Hanford Challenge

April 9, 2020

RE: Comments on the Waste Treatment and Immobilization Plant Risk Assessment permit modification

Figure 5-5. Unmitigated Vulnerabilities Identified for Radiological Control and Industrial Safety and Hygiene.

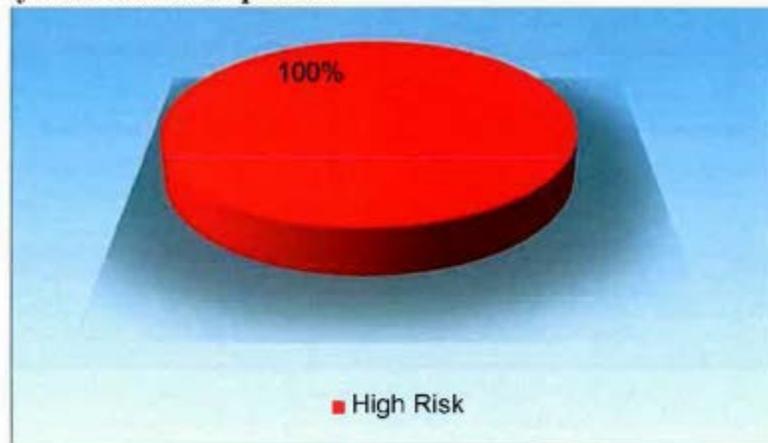
A total of eight (8) vulnerabilities were identified for the radiological control and industrial safety review area. Figure 5-5 shows that the vulnerabilities identified for the system were all considered high impact for which mitigation is recommended prior to cold commissioning and preferably prior to startup testing.

The review team identified specific issues with the radiological control approach all of which will require correction prior to startup testing. Listed below are summarized vulnerabilities:
